Project Description – 1201 Abercorn Street

This application covers two minor changes to the project originally proposed and approved by the Historic Preservation Commission in COA 24-002994. Besides the changes listed below, the exterior scope remains the same as originally approved. This application only contains information about the changes.

1201 ABERCORN IMPROVEMENTS

4 FRONT RAIL w/ WALL TERMINATION
1/2" = 1'-0"

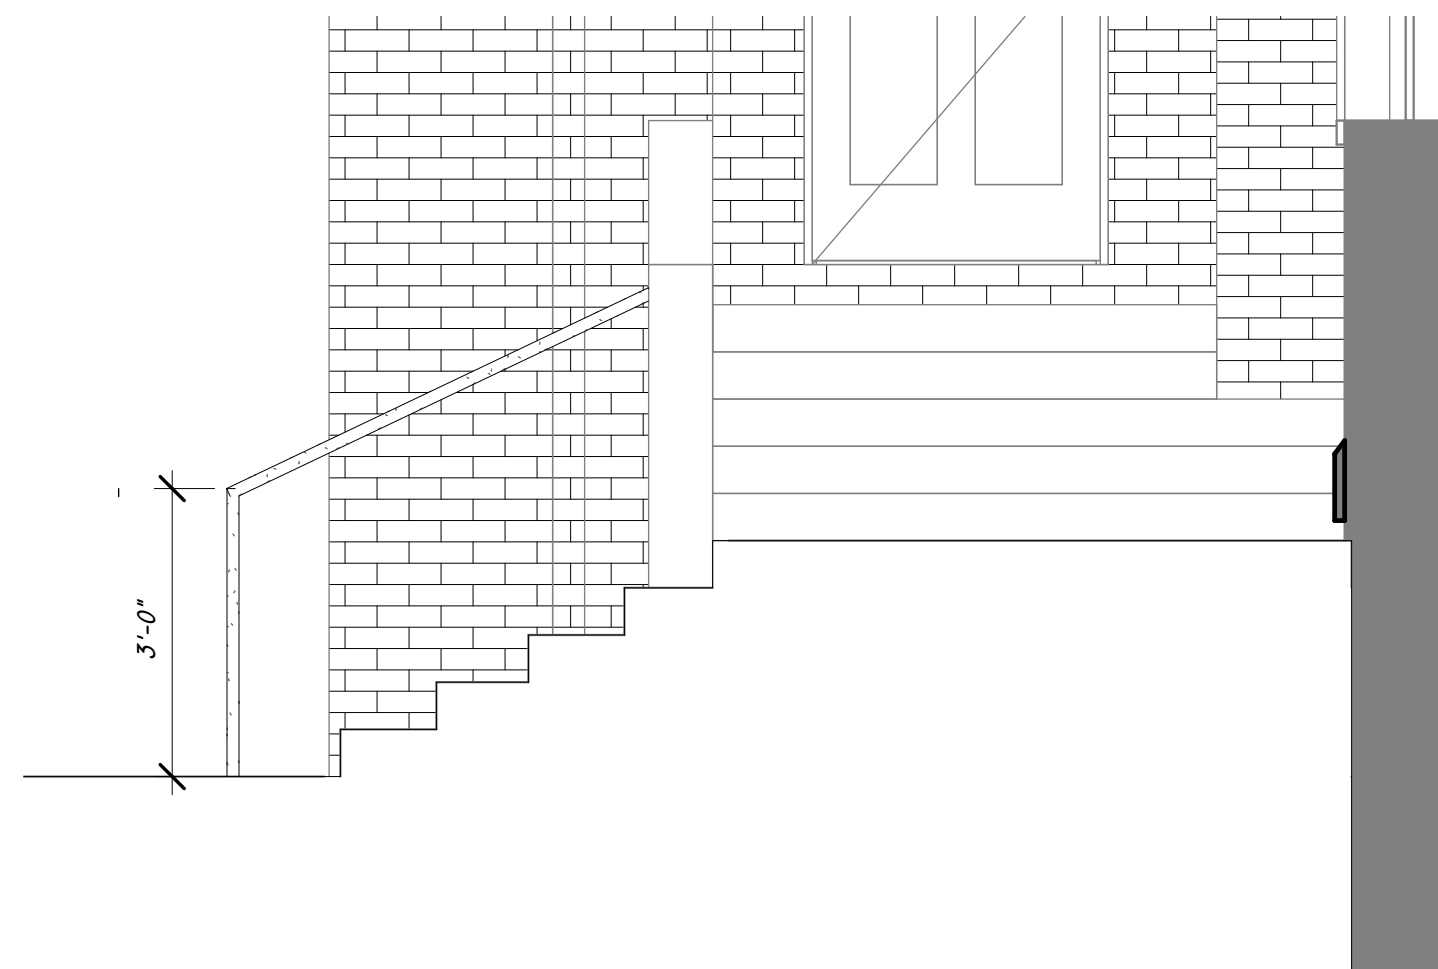
The handrails on the main steps on the east elevation (front) were removed per the previous proposal. In order to meet life/safety codes, new handrails will be installed. The new handrails will be simple metal handrails that are finished with a dark powder coated finish. These handrails will be minimally visible once installed. See sheets A1.1 and A5.3 for locations and details of these handrails.
